Energy Plant Repairs and Modifications University of South Carolina State Project Number: H27-Z215

Addendum 3

November 8, 2017

2.1 SCHEDULE OF PIPING

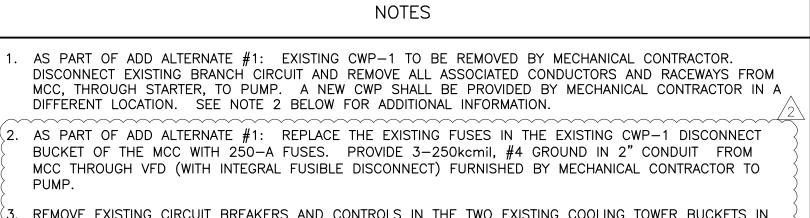
- 1. <u>Revision:</u> Reference Addendum 2 Item 4. The question was asked if standard wall pipe is acceptable for pipe that is 12" and larger. Delete previous response in Item 4. Standard wall pipe for pipe 12" and larger is acceptable.
- 2. <u>Revision:</u> Reference Section 230500 HVAC. Reference Paragraph 2.3. Change this section to read as follows. Note that butt-weld fittings are at the contractor's option.

SERVICE	ITEM	PIPING	FITTINGS	FLANGES OR UNIONS
Condenser Water - Open Loop (within building and underground)	10" & Smaller	Black steel steel Sch. 40 ASTM A-53	Butt-weld black steel steel Sch. 40	150 lb. forged black steel steel
Condenser Water - Open Loop (within building and underground)	12" & Larger	Black steel steel STD weight ASTM A-53	Butt-weld black steel steel Sch. 40	150 lb. forged black steel steel

WEST ENERGY FACILITY BASEMENT ELECTRICAL PLAN

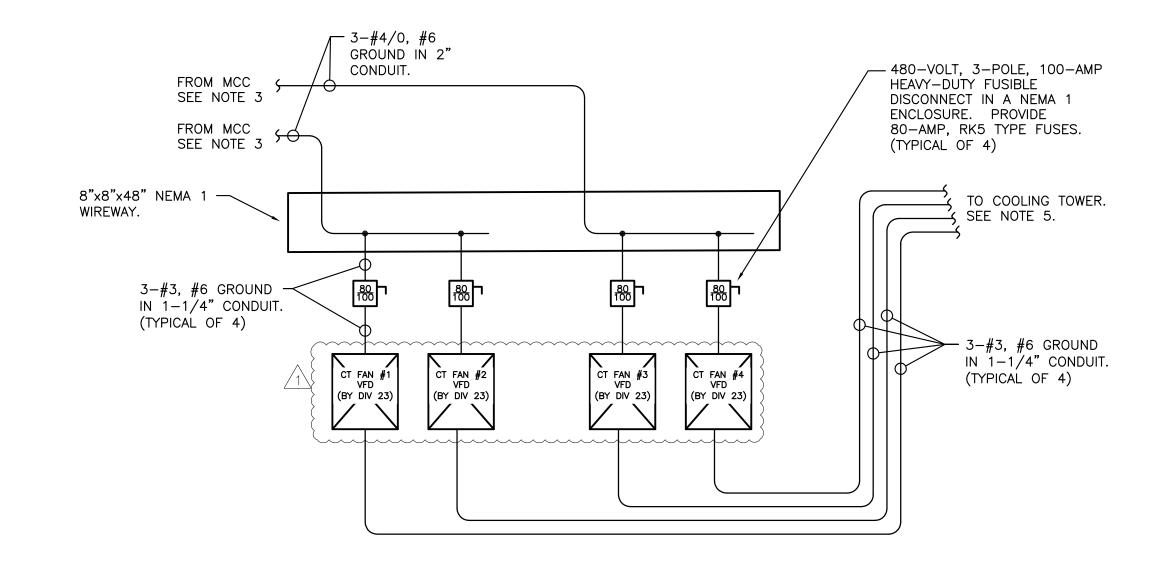
- 1. <u>Revision:</u> Reference Drawing M1 Site Plan at Blossom St. Where underground pipe is routed, contractor shall saw cut existing asphalt and patch asphalt to SCDOT Standard Specifications. Where underground pipe is routed, contractor shall saw cut existing sidewalk and patch sidewalk to match existing.
- 2. <u>Revision:</u> Reference Drawing E1 West Energy Facility Basement Electrical Plan. See attached revised drawing. This drawing revises the MCC modifications in notes 2, 3, and 6.

(3. REMOVE EXISTING CIRCUIT BREAKERS AND CONTROLS IN THE TWO EXISTING COOLING TOWER BUCKETS IN THE EXISTING MCC. PROVIDE A NEW BUCKET AND A 200-A CIRCUIT BREAKER IN EACH SPARE COMPARTMENT ABOVE EXISTING CONTROLS BUCKET TO FEED TWO COOLING TOWER FANS EACH. THE FEEDERS SHALL BE ROUTED TO A WIRING TROUGH ADJACENT TO COOLING TOWER FAN STARTER LOCATIONS SHOWN.

4. PROVIDE WIREWAY AND FUSED DISCONNECTS AT LOCATION OF COOLING TOWER FAN VFD'S. SEE DETAIL 3 / E2 FOR ADDITIONAL INFORMATION.

5. ROUTE RACEWAYS FROM STARTERS (FANS) AND MCC (HEATERS) TO COOLING TOWER. ROUTE OVERHEAD IN BASEMENT AS MUCH AS PRACTICAL AND PENETRATE EXTERIOR WALL BELOW GRADE AND EXTEND TO COOLING TOWER. SEE ELECTRICAL SITE PLAN ON SHEET E1 FOR ADDITIONAL INFORMATION.

6. REMOVE EXISTING CONTROLS IN THE TWO EXISTING COOLING TOWER HEATER BUCKETS IN THE EXISTING MCC. EXISTING 50-A CIRCUIT BREAKERS IN EACH BUCKET SHALL BE RE-USED TO FEED THE BASIN HEATERS AT THE COOLING TOWER. PROVIDE 3-#6, #8 GROUND IN 1" CONDUIT ROUTED TO COOLING TOWER ADJACENT TO COOLING TOWER FAN BRANCH CIRCUITS. SEE SHEET E1 FOR ADDITIONAL

7. EXISTING PANEL "C" IS A 120/208-VOLT PANELBOARD. THERE IS AN EXISTING SPARE 70-AMP, 2-POLE CIRCUIT BREAKER IN SPACE 2,4 OF THE PANEL. REMOVE EXISTING BREAKER AND REPLACE WITH TWO 20-AMP, 1-POLE CIRCUIT BREAKERS IN THESE SPACES FOR CONTROL POWER.
